Planner Report #1

Subject: **Application #1037**
309 South Orange Avenue (Block 1009, Lot 32)
Use Variance Application

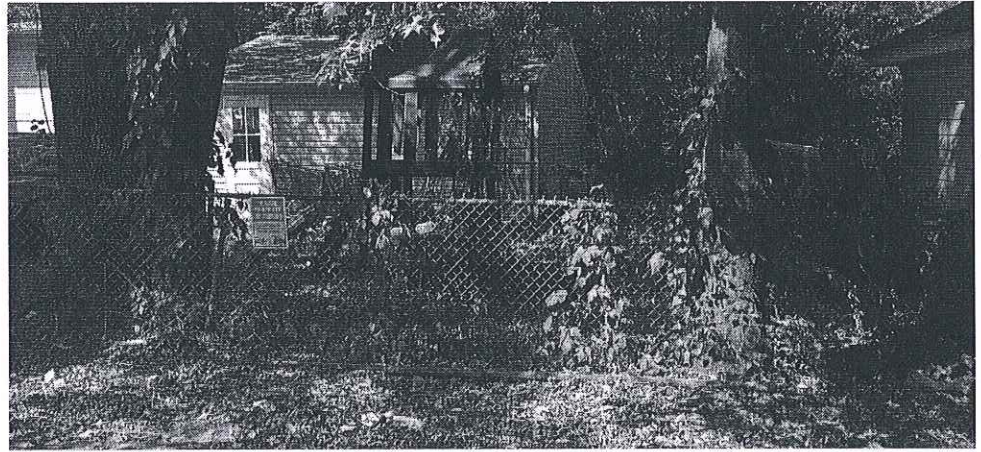
Additionally, the deck in the rear of the property is in a state of disrepair. The Applicant should testify whether it presents a safety risk to the occupants of the property, as well as its negative visual impact to neighboring properties.
